Linda Bagby
Engineering Note

Project: MicroBooNE D0DAQ Test Stand Readout Rack ORC

Doc. No: B121812_Bagby_D0DAQ_TS_Readout_Rack

Subject: MicroBooNE D0DAQ Test Stand-Readout Rack ORC Request

Figure 2: FEM 1A and 5A Fuse Labels

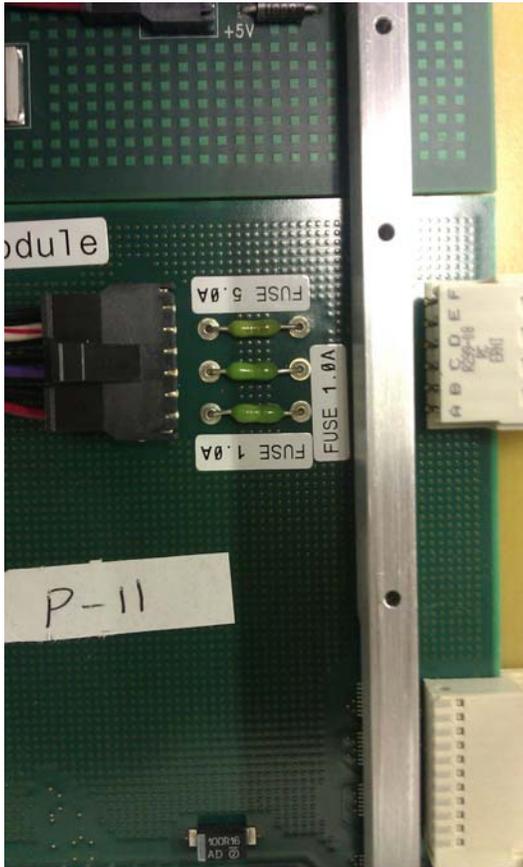
FEM: Label fuse values on board. (Shown in Figures 2 and 3.)

All of the issues have been addressed in the D0DAQ Readout crate.

Figure 4: DC Distribution

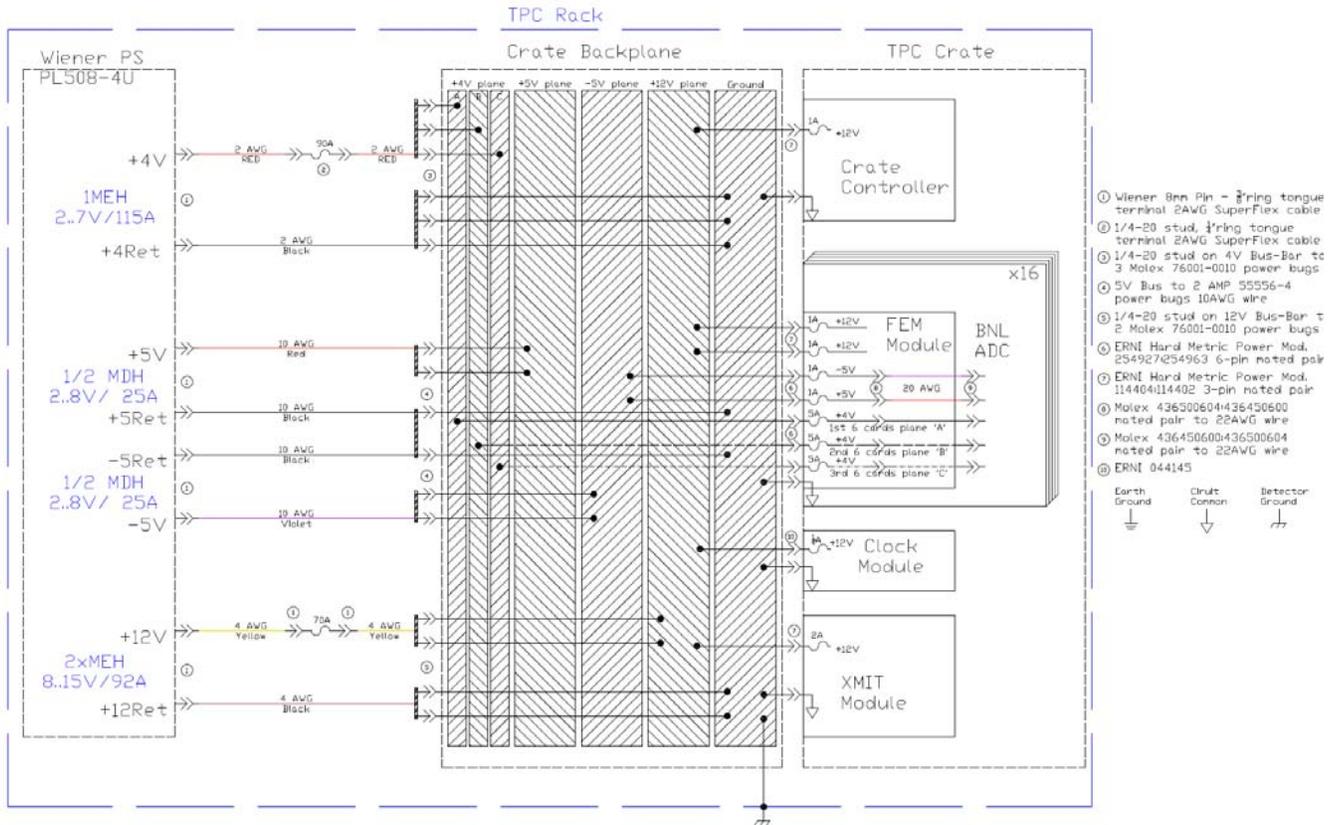
DC Distribution: Cover rear of crate with Lexan to prevent accidental shorting of bus work.

Install an insulating spacer between +4V and RTN bus bars.

Mechanically restrain cables rather than using adhesive backed cable-tie anchors.

Figure 4 is the schematic for the DC Distribution circuit. Power is provided to the custom designed backplane by a Wiener PL508 power supply. Fusing is appropriate for the cable sizes as shown in the drawing. Production bus bars are used to distribute current along the backplane. A G-10 spacer has been placed between the bus bars as requested by the backplane EDR. Figure 5 illustrates the DC fusing for the Trigger Card. Bus bar calculations and Sense line fusing details can be found on Dave's website under DC Distribution here:
